ADDENDUM NO. 1 TO 18-0115-4

FOR: BENTON BOULEVARD EXTENSION

Bid No. 18-0115-4
BENTON BOULEVARD EXTENSION
PRE-BID QUESTIONS

TYPICAL SECTIONS

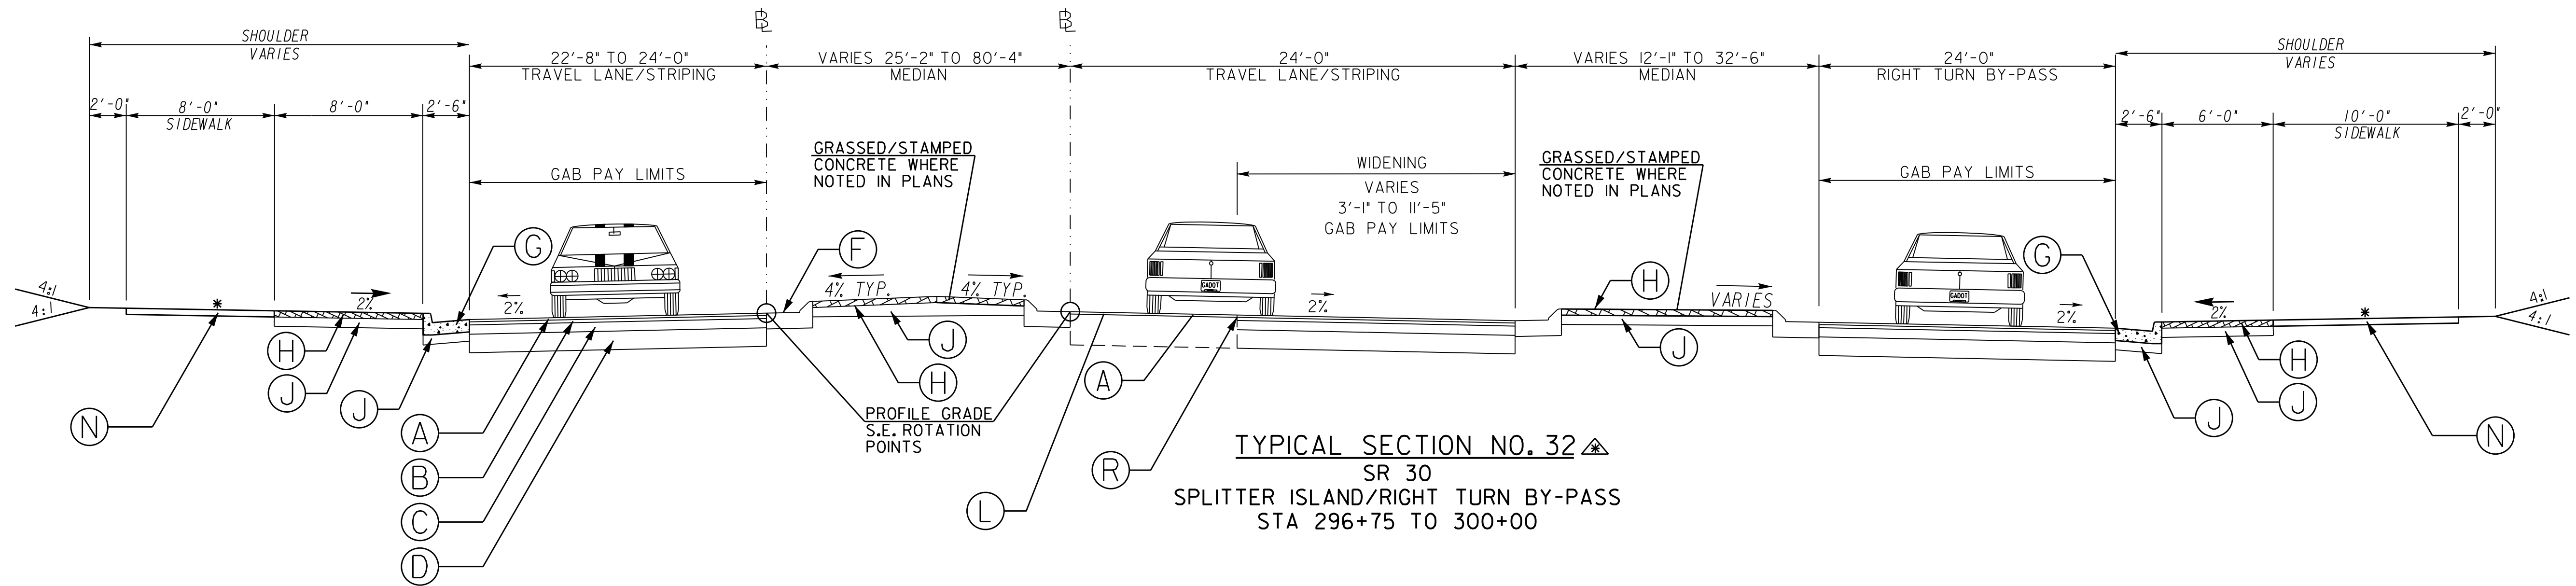
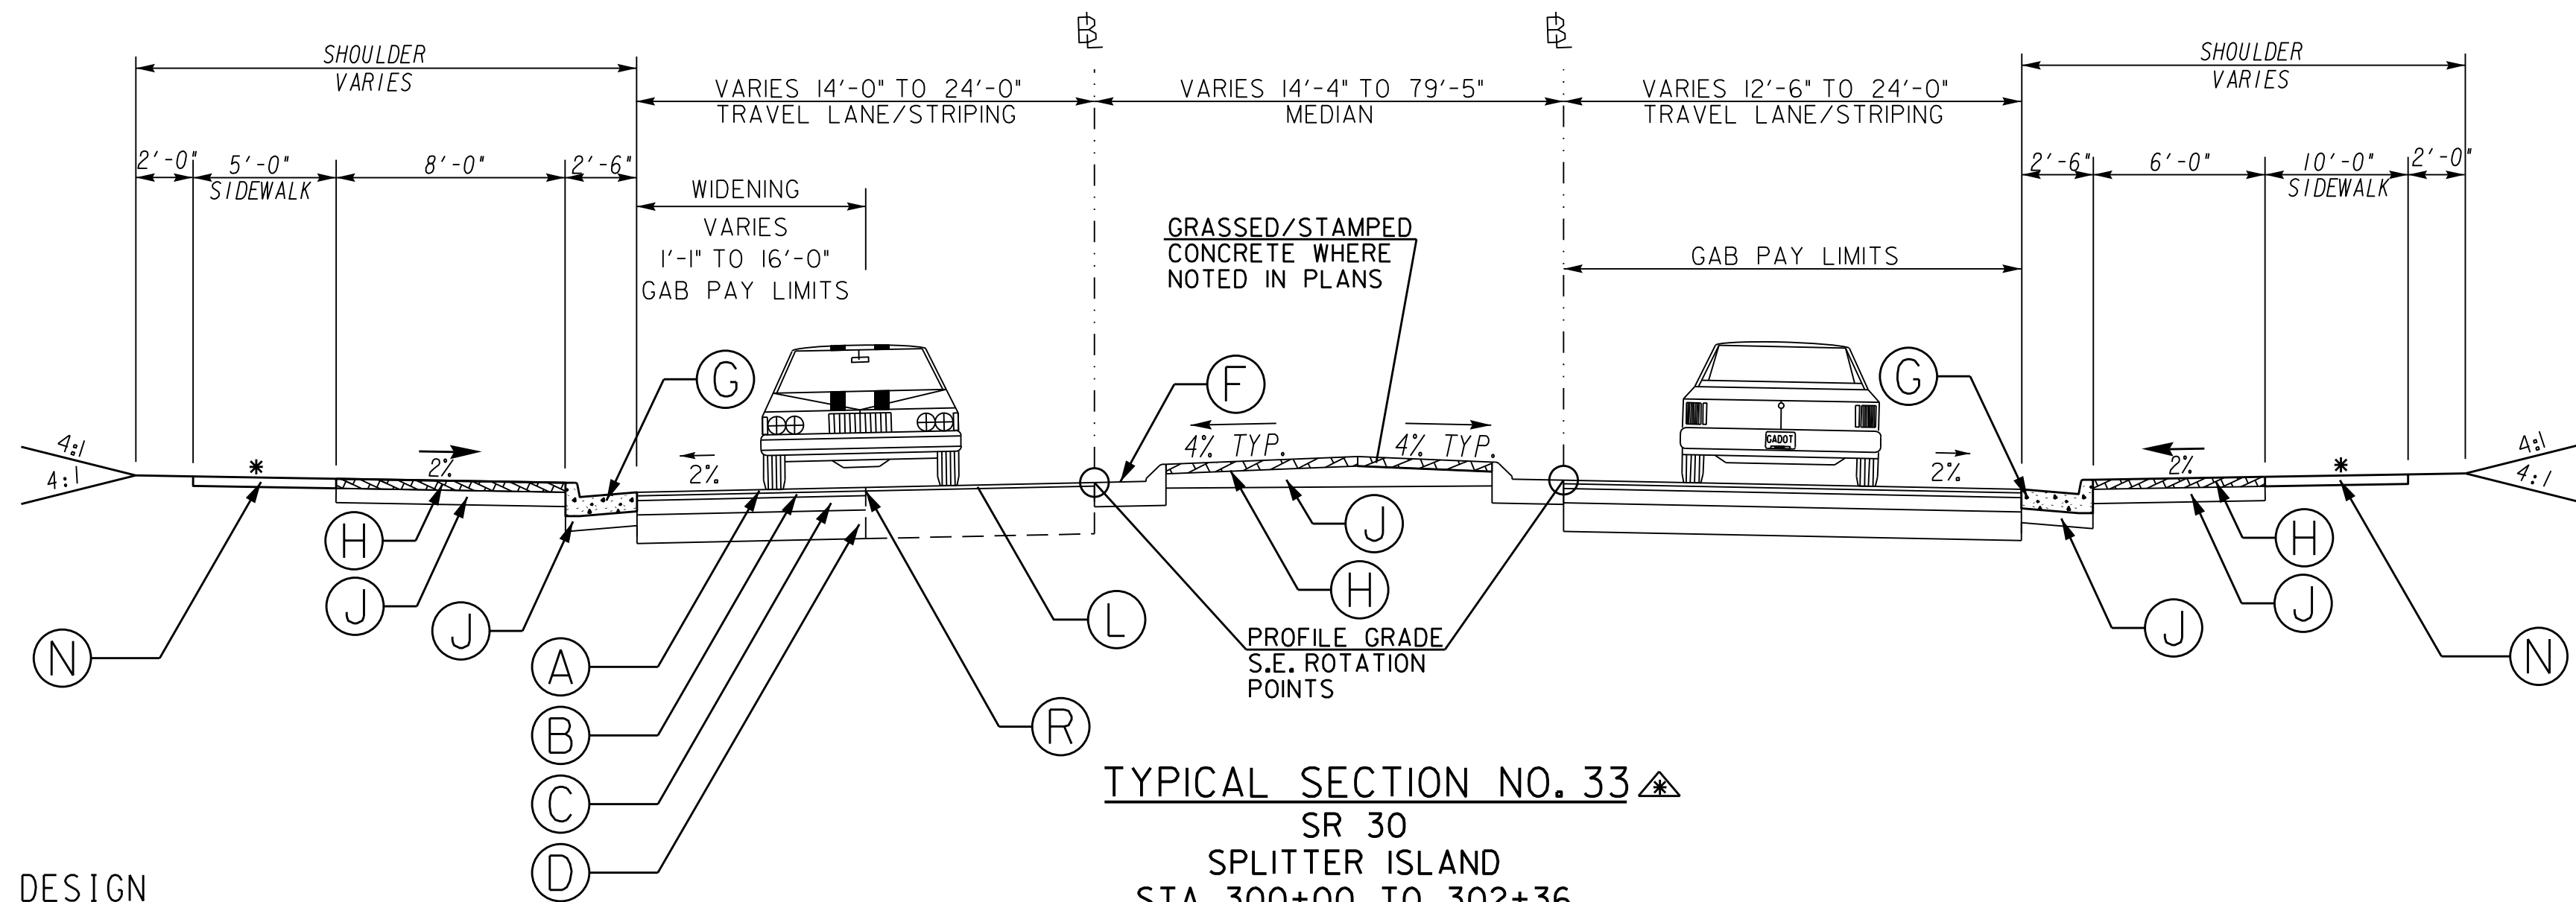
11. What does the dash line represent near the existing travel lane on SR 30 and Highlands. Sheet 13-002 calls out dash line as “limits of overlay” this does conflict with typical sections on SR 30.

Answer 11. The existing pavement to remain is outlined with a hatched border that is called out as ‘limits of overlay’ on the plan sheets. The plan sheets and cross sections are correct. The typical sections are incorrect. See revised sheets.

| (A) 165 LB/SY RECYCLED ASPH CONC 12.5MM SUPERPAVE, GROUP 2 ONLY, INCL BITUM MATL & H LIME | (H) 4" THICK STAMPED CONCRETE, COLORED & SEALED SEE SHEET 5-0015 FOR DETAIL |

- (A) 165 LB/SY RECYCLED ASPH CONC 12.5MM SUPERPAVE, GROUP 2 ONLY, INCL BITUM MATL & H LIME
